RIEDESEL AVENUE

Concept 3

NOT FINAL DESIGN FOR DISCUSSION ONLY

**RIEDESEL AVENUE
CAMBRIDGE, MASSACHUSETTS**

Concept 3

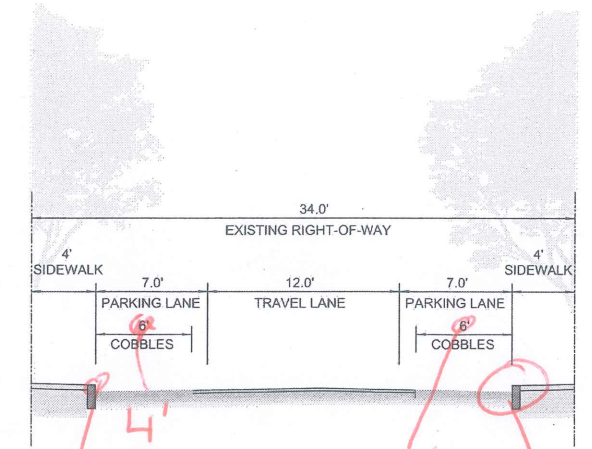
eliminate mid block crosswalk & associated bump outs

Typical Section

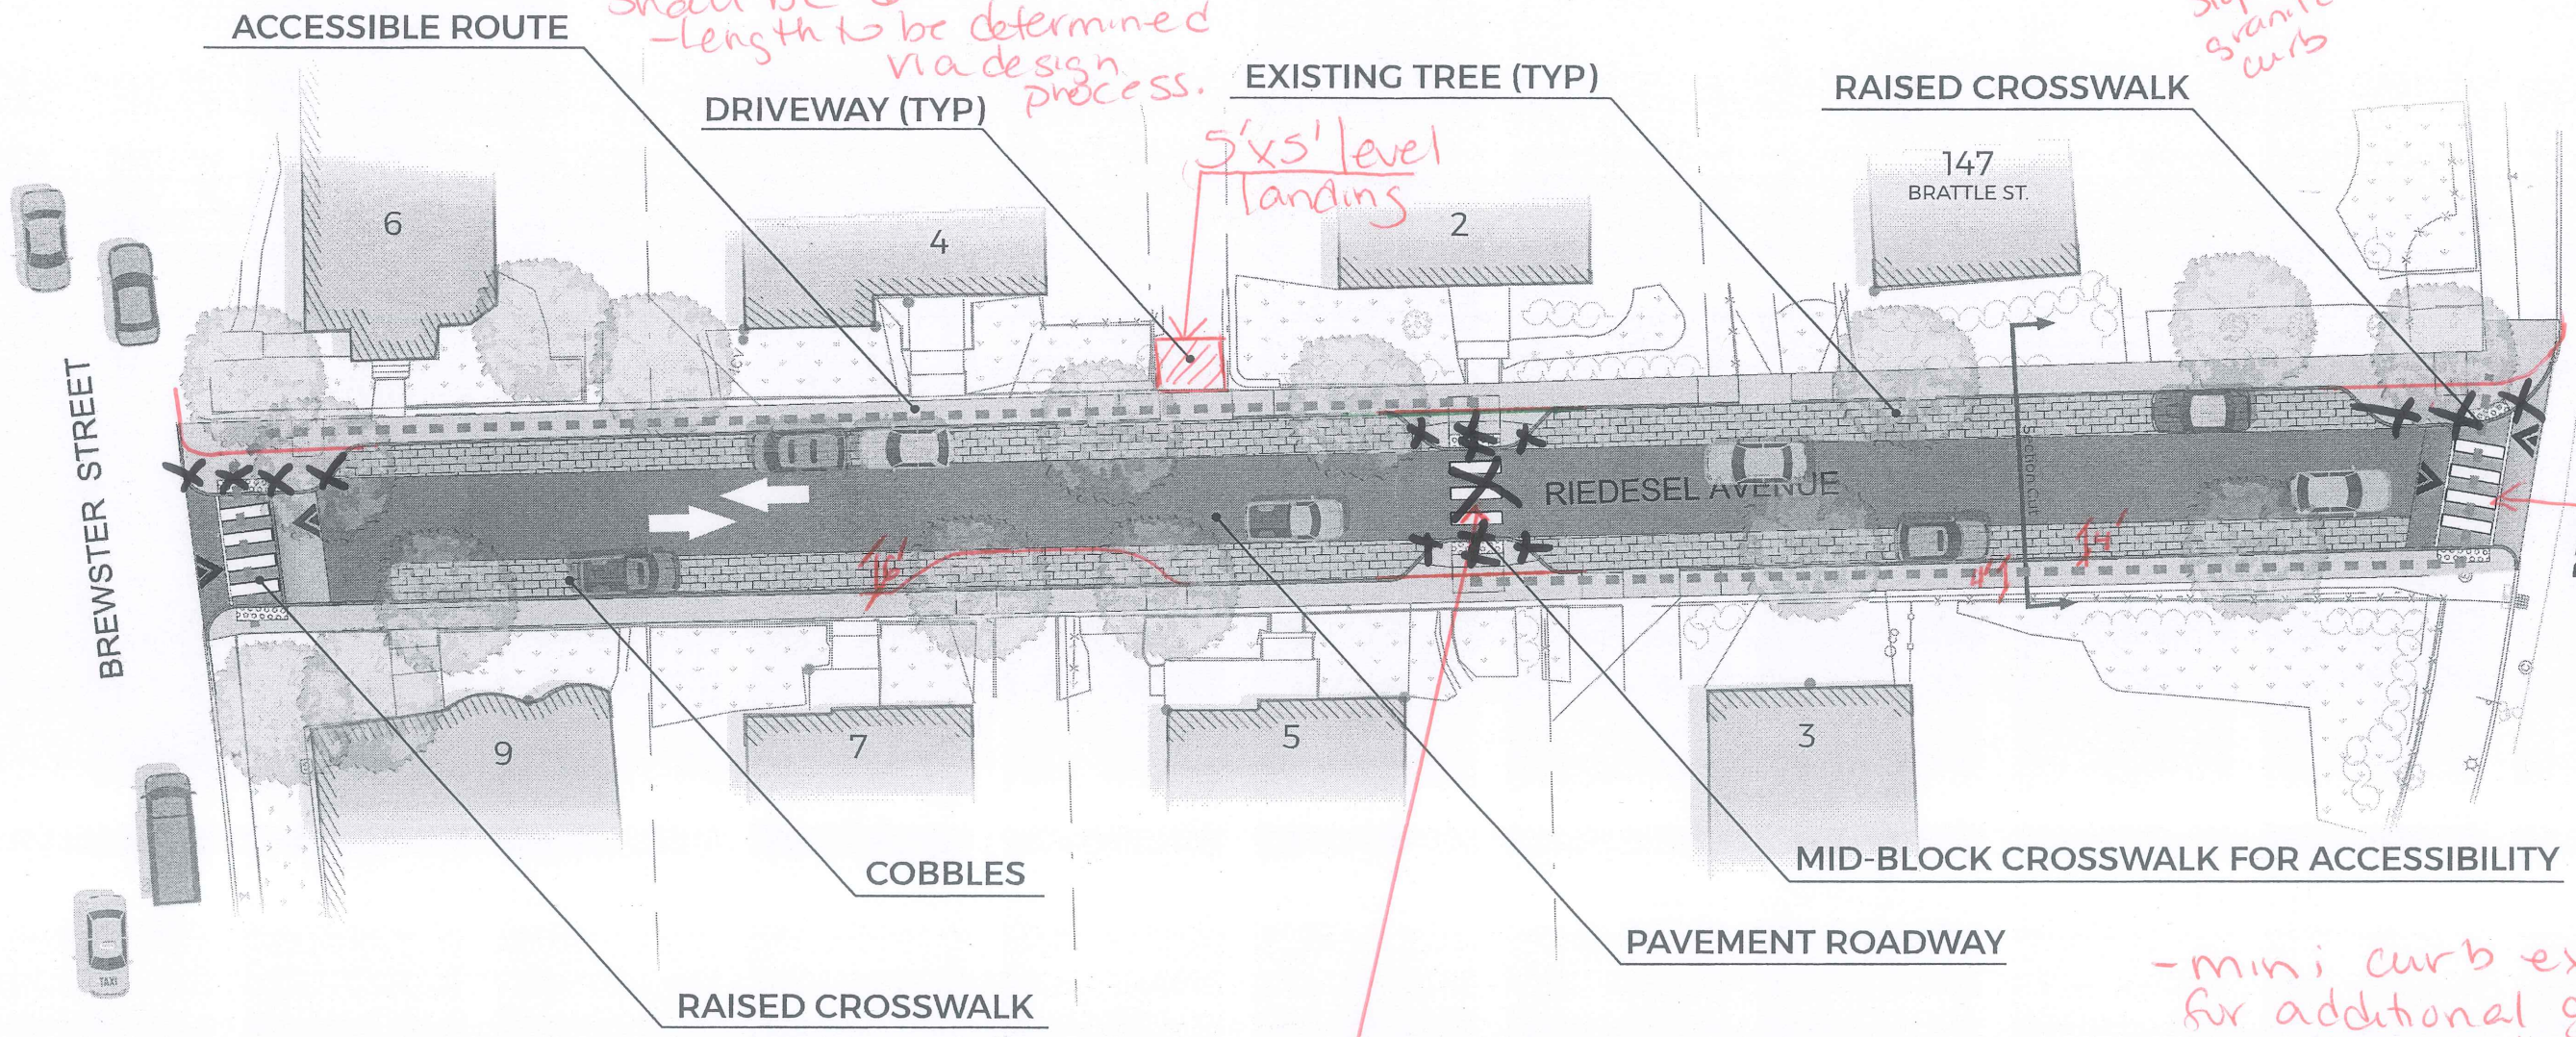
- Sidewalks (concrete) on both sides of street shall be 4' in width

- width of cobble detail on both sides of street shall be 4'

- width of bump out shall be 6' - length to be determined via design process.

curb shall be sloped granite curbs shown on attached photo

sight line evaluations to be done during design process

- mini curb extensions for additional green space to be located during design process.

- updated from feedback received @ community meeting on 2/13/18.
